**FOCUSED FEASIBILITY STUDY:
DUNN FIELD**

**DEFENSE DISTRIBUTION MEMPHIS, TENNESSEE
MEMPHIS, TENNESSEE**

Defense Depot Memphis, Tennessee (DDMT)
Response to
Tennessee Department of Environment and Conservation (TDEC)
Division of Superfund
Comments for the
Draft Final
Engineering Report
Removal Action for Ground Water
7/12/94

FIGURE 3.2:
TOPOGRAPHY OF
DUNN FIELD VICINITY

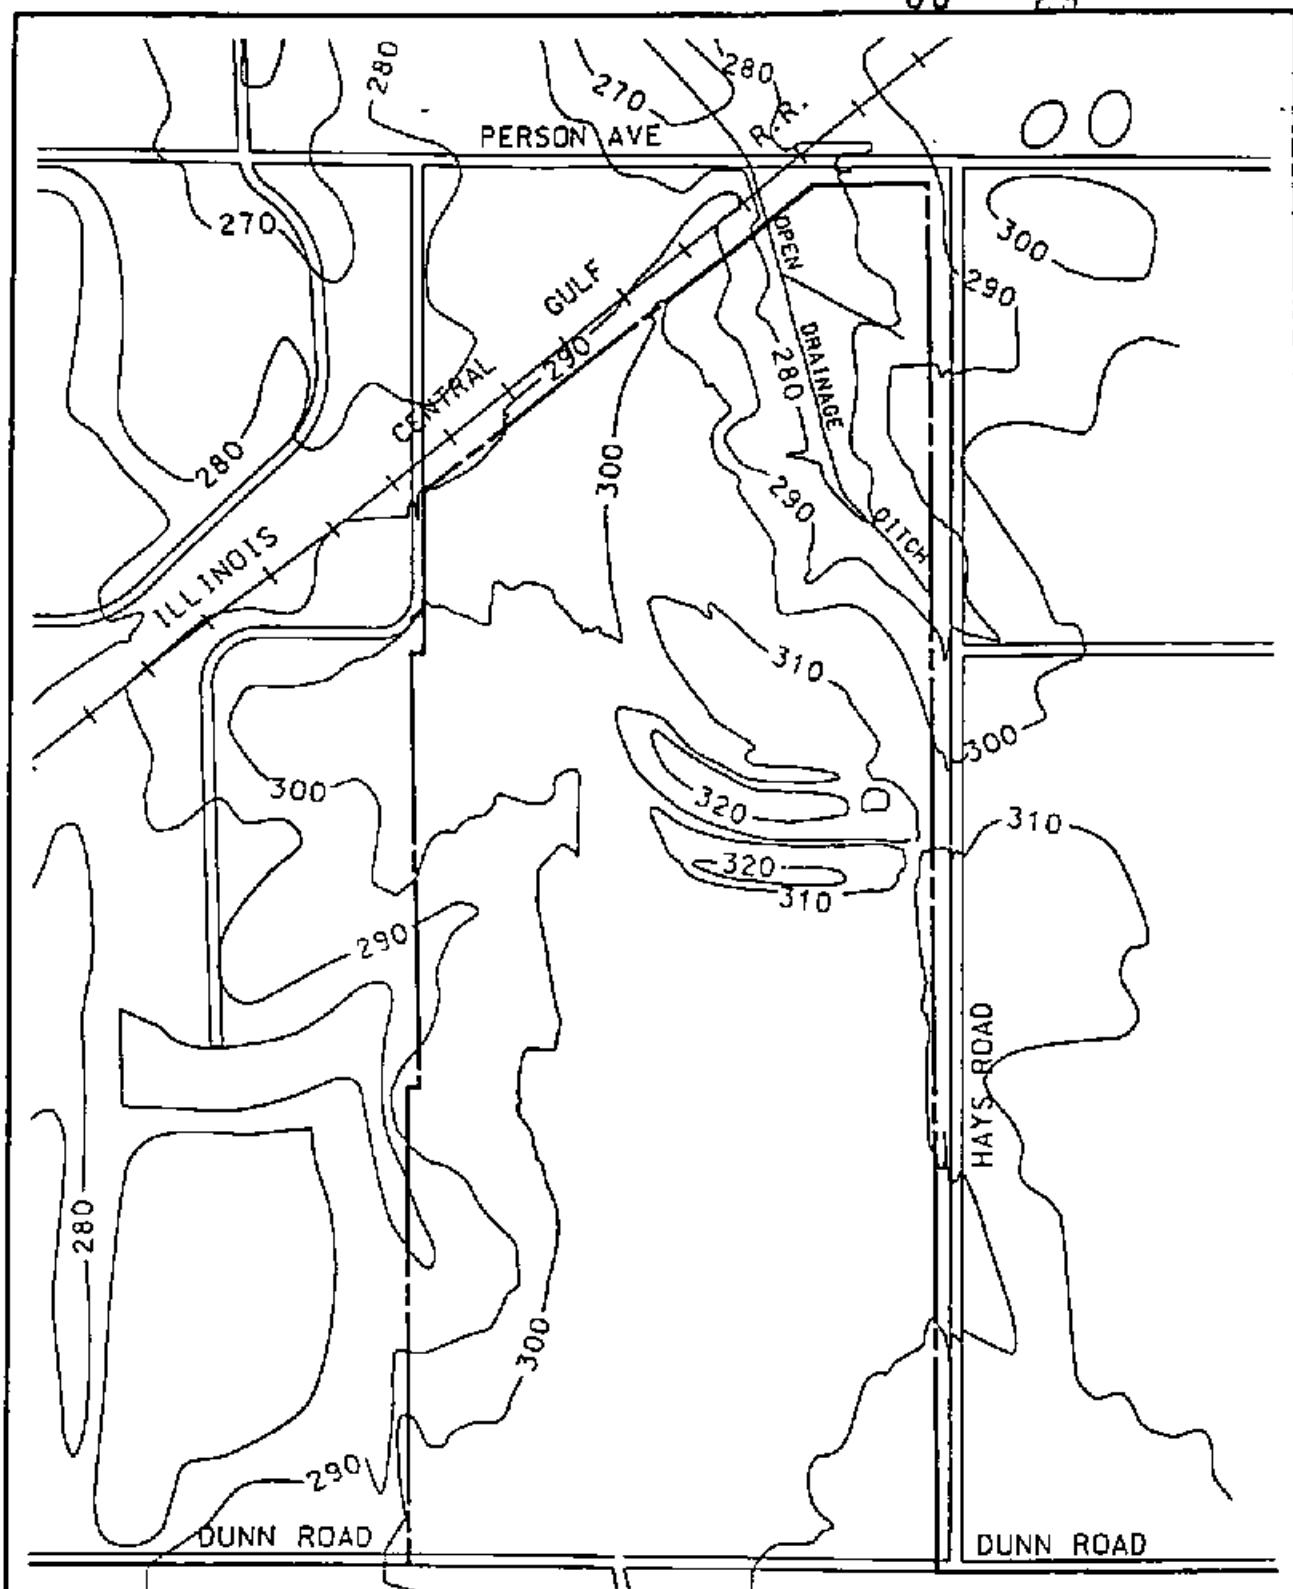
3. Figure 3.2, Page 3-4--Although the map legend does not indicate a contour interval, the interval appears to be 10'. In the lower left of the map, two closed loop contours are not marked. This actually appears to be an error in contouring.

DDMT response to TDEC Comment 3. Concur. Future contour maps will adequately address the contouring in the southwest corner of Dunn Field.
